Revisions following officers comments:

Drawing Number: 2025/01

Project: Proposed details

145 Western Road

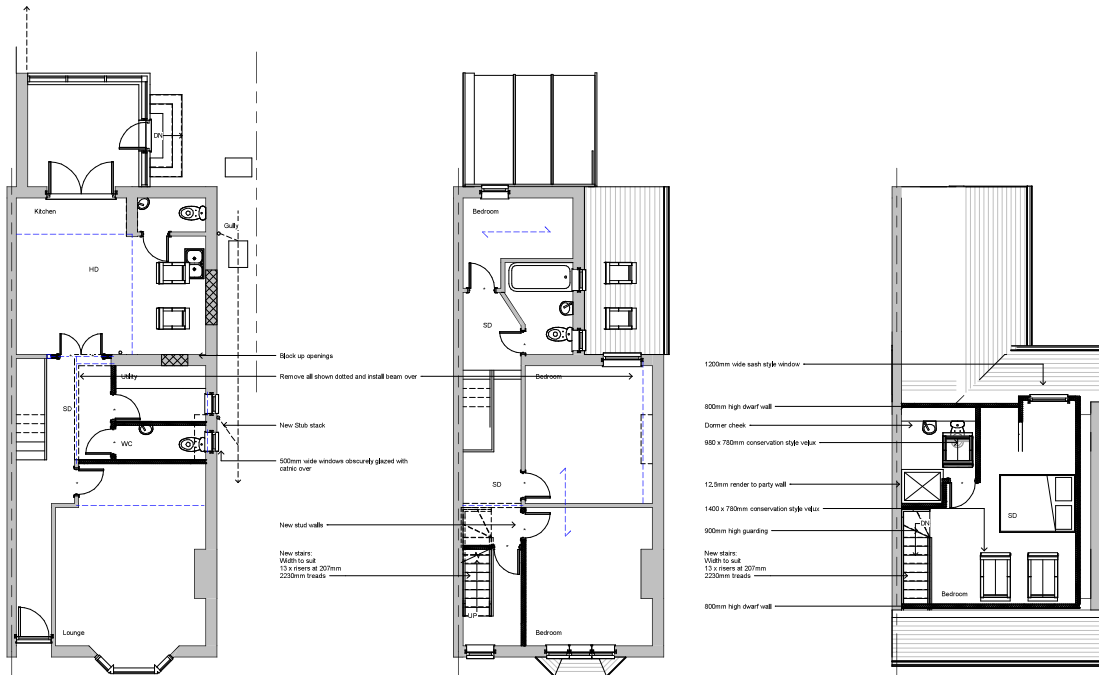
A - 1 x dormer removed and remaining dormer reduced, rear valua to serve usable

B - Dormer window reduced to match width of first floor
